Office Action Summary	Application No. 10/575,052	Applicant(s) LAMBERT ET AL.	
	Examiner JUSTIN JONAITIS	Art Unit 3752

DETAILED ACTION

3. Claims 1, 3-4 , 12 rejected under 35 U.S.C. 102(b) as being anticipated by U.S. Patent #4,153,205 to Parrish, Jr.

Figure 3 of U.S. Patent #4,153,205 reproduced with examiner's interpretation

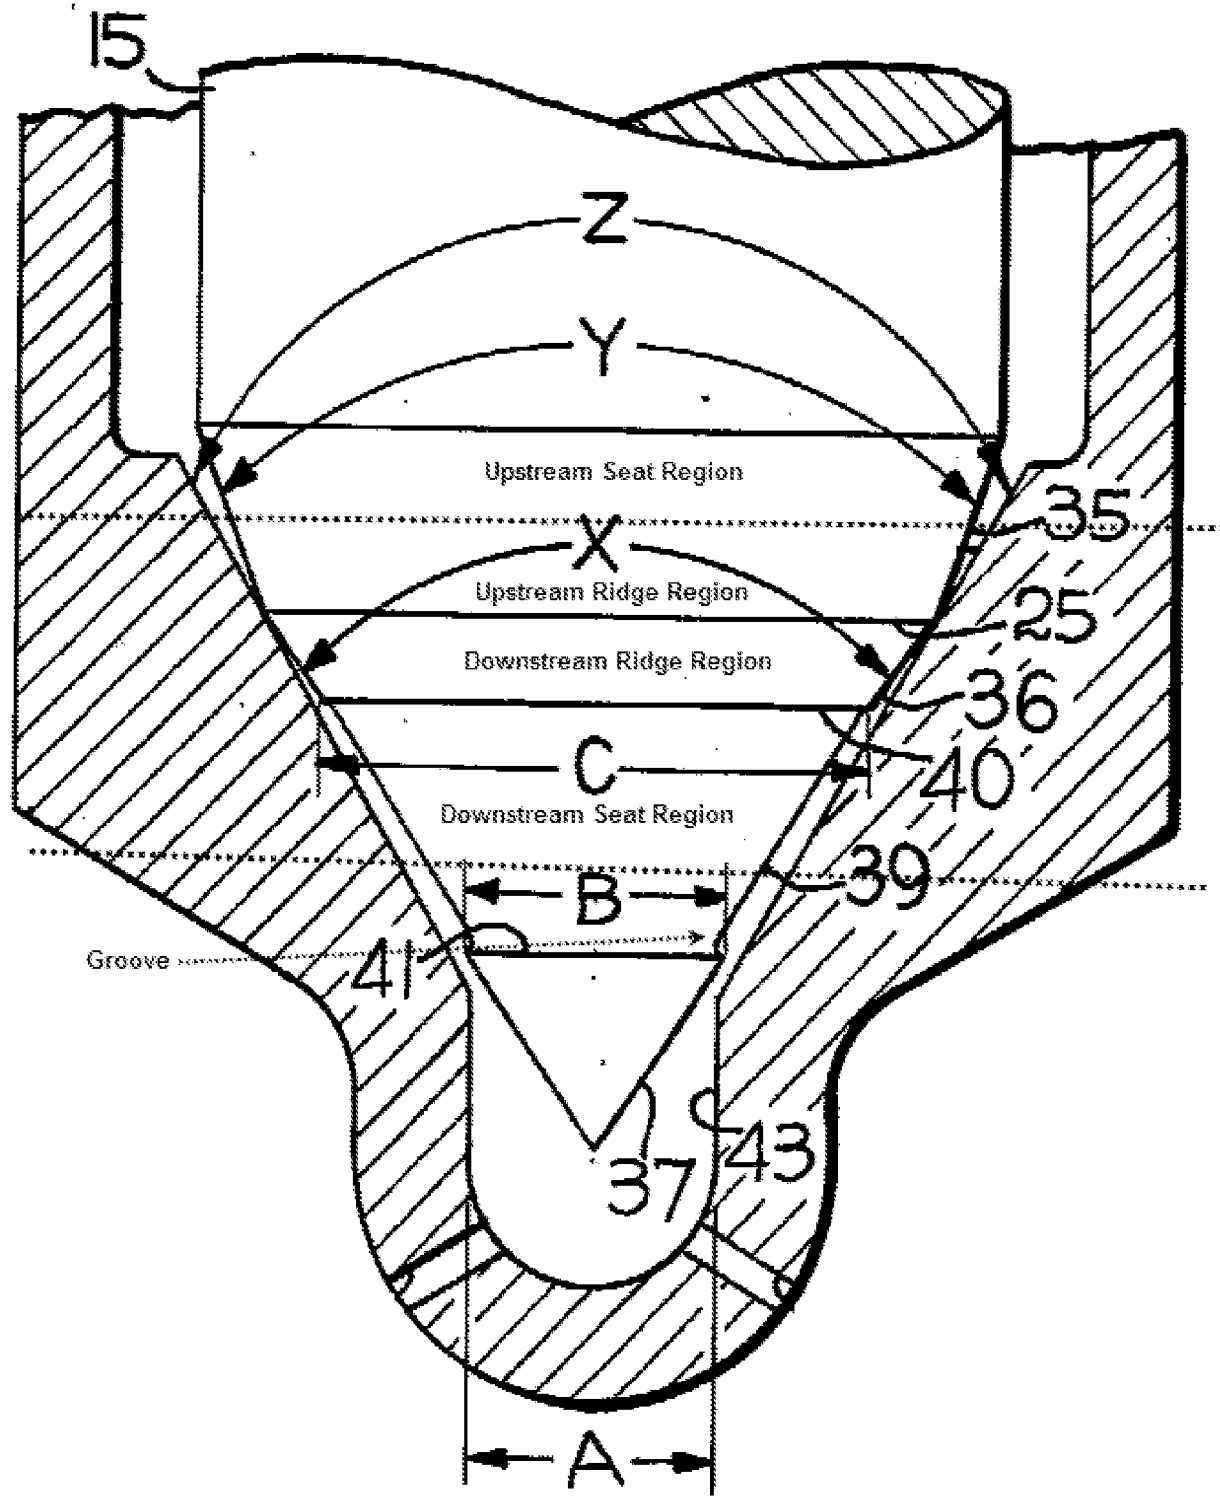
Parrish, Jr. Discloses an Sac-type injection nozzle [column 3, lines 50-52] for an internal combustion engine, the injection nozzle comprising a nozzle body (1) provided with a bore (chamber (24)) defining a valve seating surface (cone surface (49)) having a seat cone angle (Angle Z), a valve member (valve (15)) which is moveable within the bore. The valve member including an upstream seat region (the top half of upper conical surface (25), See Figure above for further clarity of examiner's interpretation) defines an upstream cone angle (Angle Y), the upstream cone angle and the seat cone angle together defining an upstream differential angle between them.

The valve member further including a downstream seat region (the top portion of groove region (39), See Figure above for further clarity of examiner's interpretation) which defines a downstream cone angle that with the seat cone angle defines a downstream differential angle between them. The valve member also includes an annular ridge (defined by the bottom half of upper conical surface (35) and lower conical surface (36)) protruding from the downstream seat region, integral to the upstream ridge region, disposed immediately downstream of the upstream seat region, and immediately upstream of the downstream ridge region. The protruding annular ridge includes an upstream ridge region (Bottom half of the Upper Conical Surface (35), See the Figure above for clarity of examiner's interpretation) and an adjacent downstream ridge region (Lower Conical Surface (36)). The protruding annular ridge defining a seating line (valve seat seal (25)) at the intersection of the upstream and downstream ridge regions. [column 3, lines 39-43] The seating line including a seat diameter and being engageable with the valve seating surface to control fuel injection from the nozzle body.

The valve member further including a circumferential groove (lower portion of groove region (39), See the figure above for further clarity of examiner's interpretation) arranged

downstream of the downstream ridge region and immediately upstream of a further region (conical surface (37)), wherein a lower edge of the circumferential groove and the further region define an intersection which defines, together with the seating surface, a radial clearance that is sufficiently small so that a lower portion of the downstream ridge region defines a load bearing surface for the valve member.
